2.2 Consented Scheme Comparison Proposed Scheme - Second Floor

2.2 Consented Scheme Comparison Proposed Scheme - FEC, Conference Centre & Waterpark

2.2 Consented Scheme Comparison Consented Scheme 2021 - Outbuildings

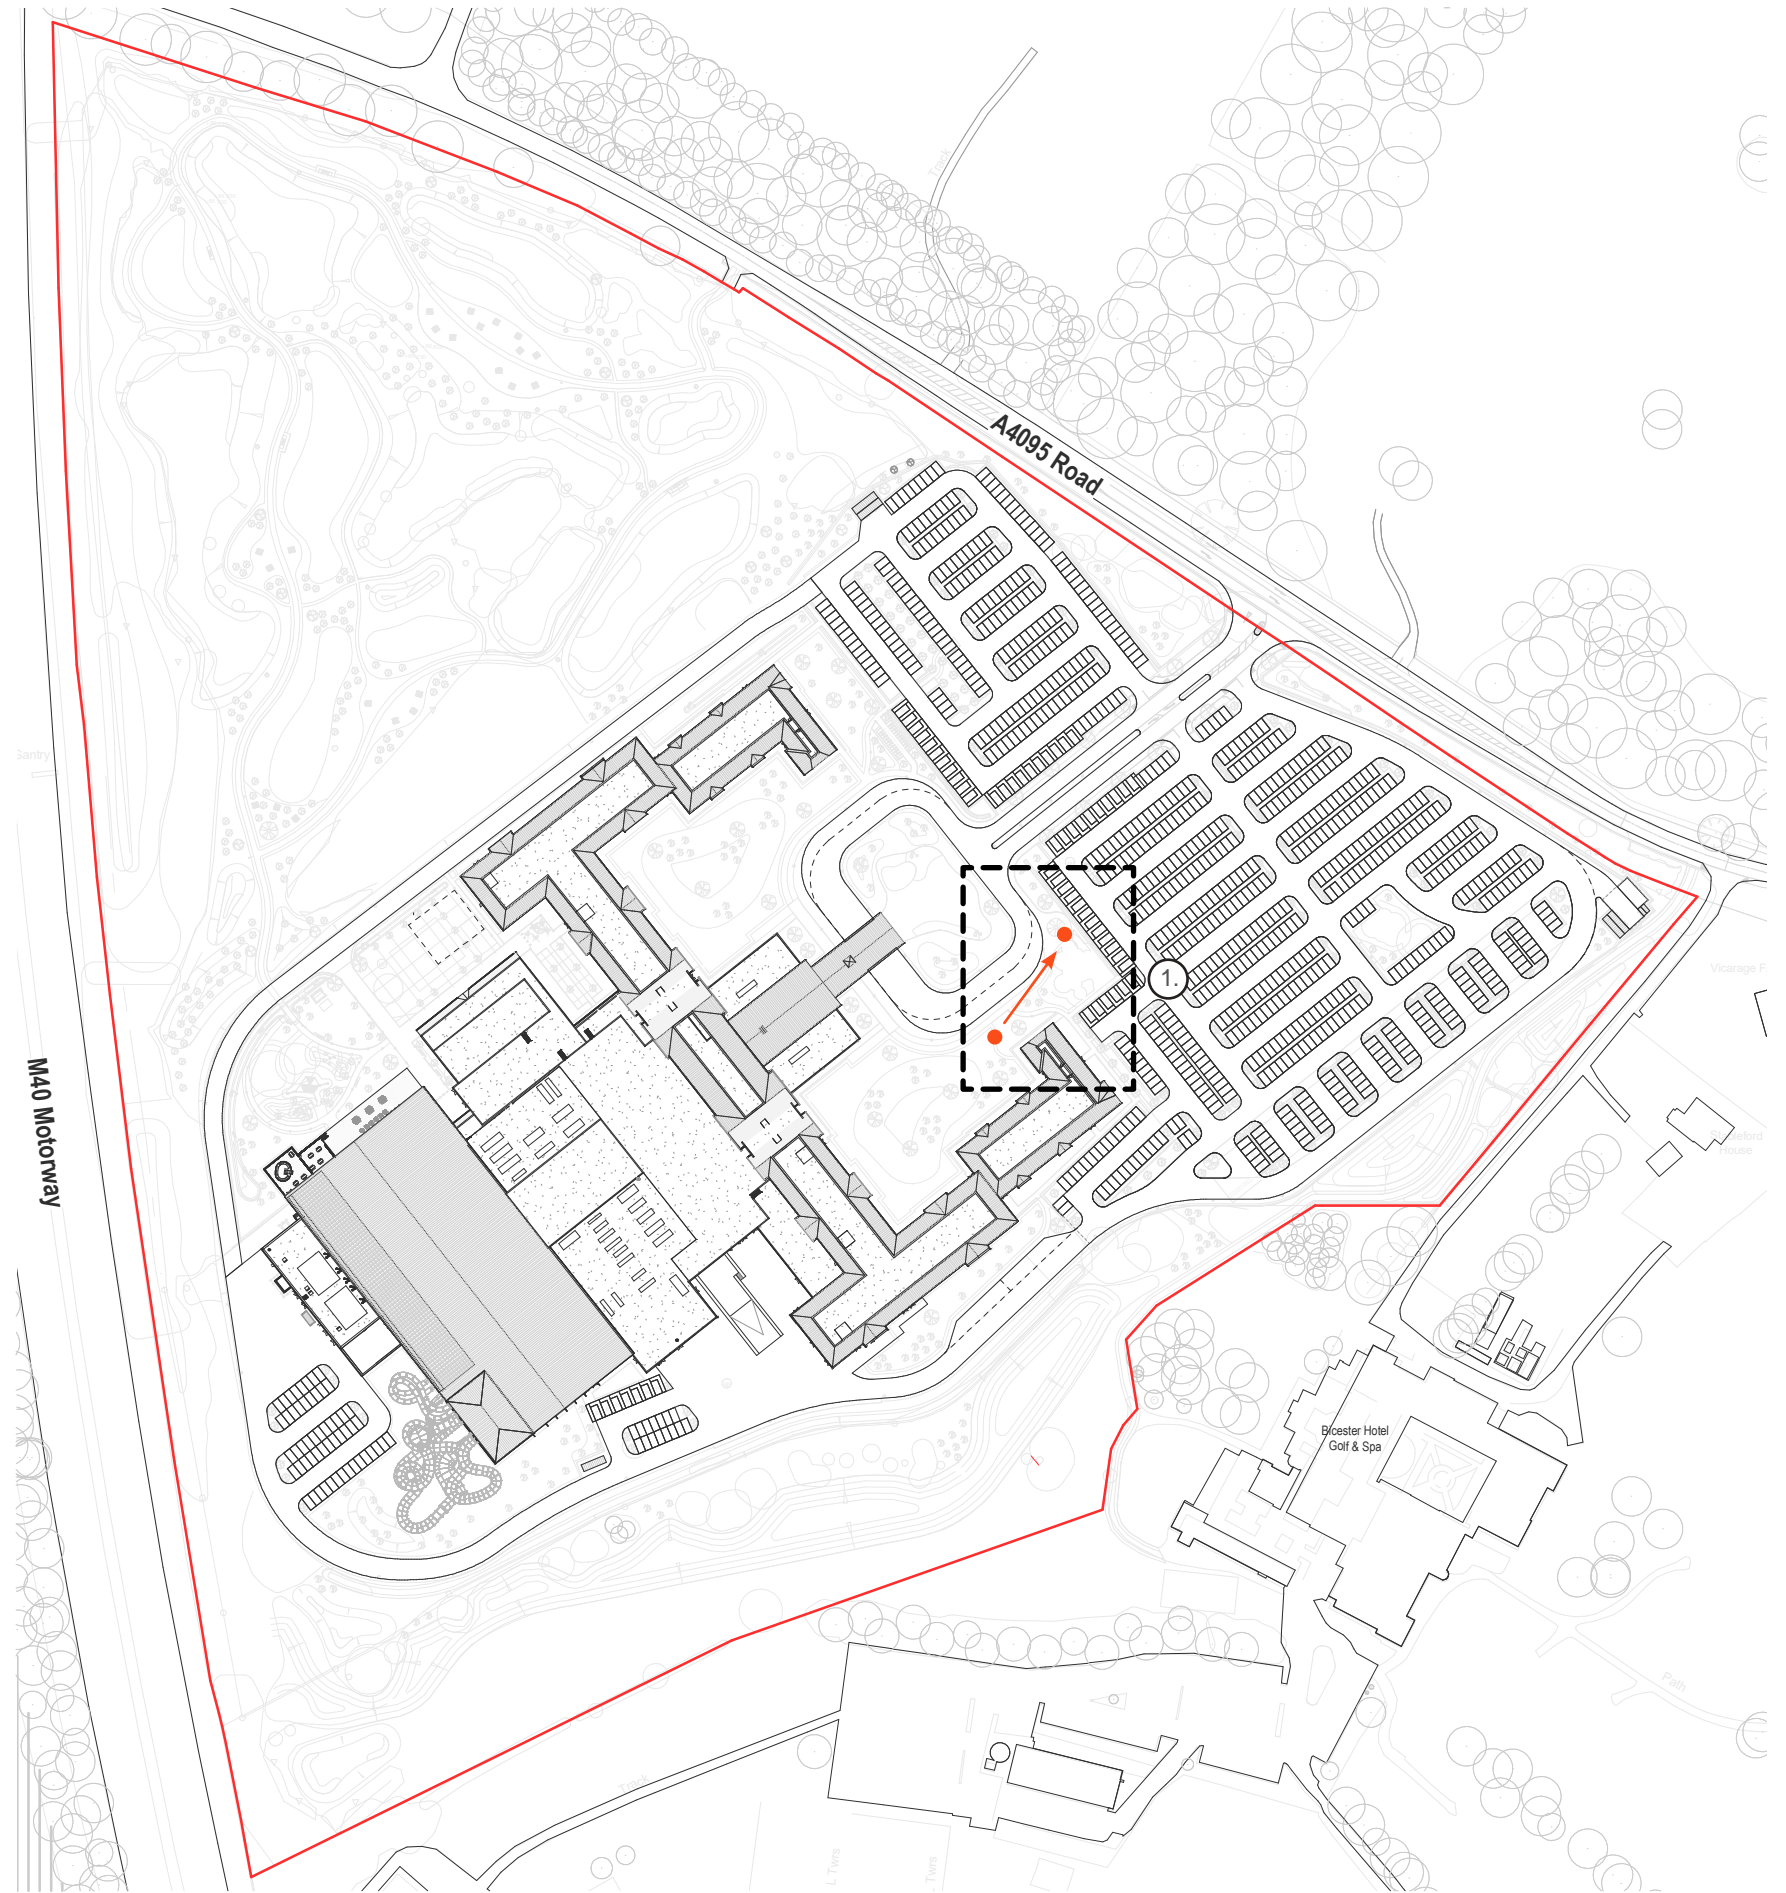
- ① Great wolf statue location relocated on the site plan to appear earlier in the guest arrival experience. Relocated to the first turning of the entry roundabout.
